THE WATER-SUPPLY AND DRAINAGE OF THE
TOWN OF MADRAS.

Report of Committee on Water-supply and Drainage of Madras.

SCHEME FOR IMPROVEMENT OF RIVER COOUM

SCHEME FOR IMPROVEMENT OF RIVER COOUM
PLAN AND SECTIONS OF THE PROPOSED ARRANGEMENTS
 — AT THE —
MOUTH OF RIVER

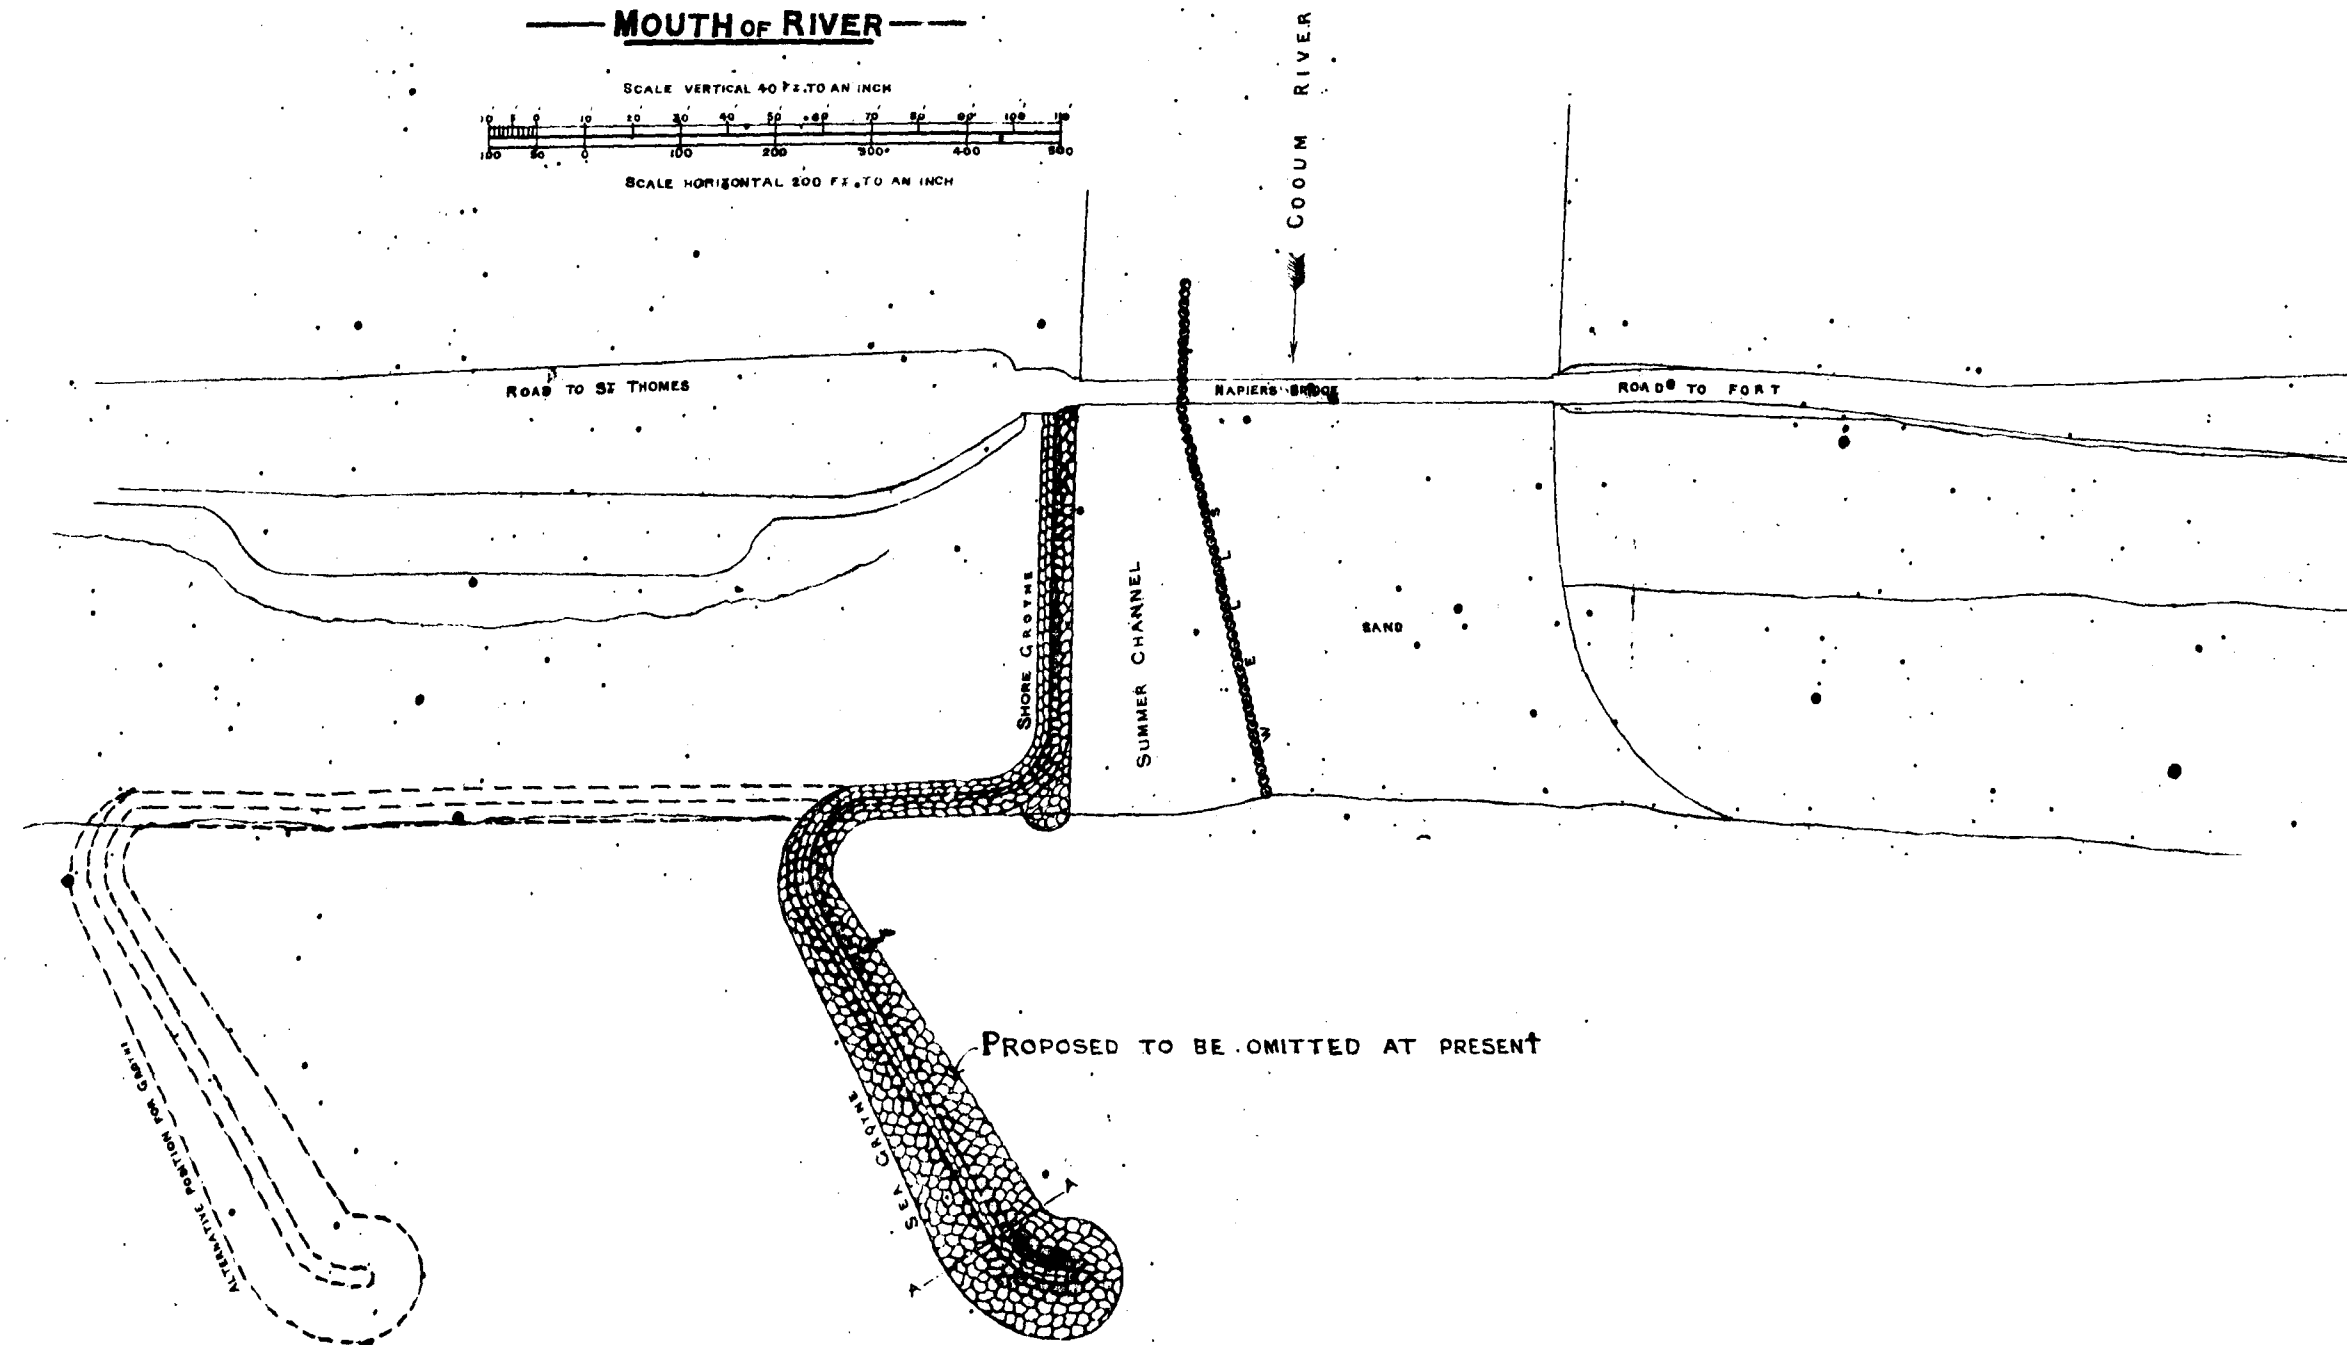
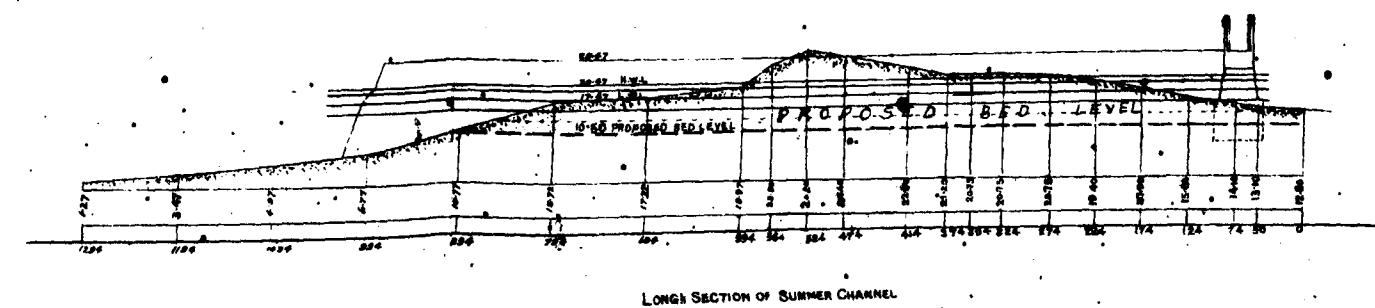
7. Mr. Jones expresses a strong opinion in favor of the first of the two schemes for dealing with the lower portion, and in paragraphs 38 to 62 of his report, he discusses the measures to be adopted for keeping the bar open and gives his reasons for considering that the groynes proposed by him will be effective.

8. I regret that I am not convinced by the arguments brought forward, and cannot concur in the proposal to keep the bar open by means of groynes.

9. In the first place, it is by no means certain that the groyne proposed would keep the river mouth open at all; that it would remove the bar from its present position is certain, but it is not equally so that the latter would not reform further inland; my own belief is that it would do so, though the question is so beset with uncertainties that it is impossible to give a positive answer to it.

10. Whether the bar would be removed or not, it is almost certain that the construction of the groynes would cause erosion of the shore to the north of the river mouth, and with the result of the construction of the harbour (which in its effect upon the coast is nothing but a big groyne) before our eyes, I cannot but think it would be highly unwise to construct any more sea groynes in the neighbourhood of Madras.
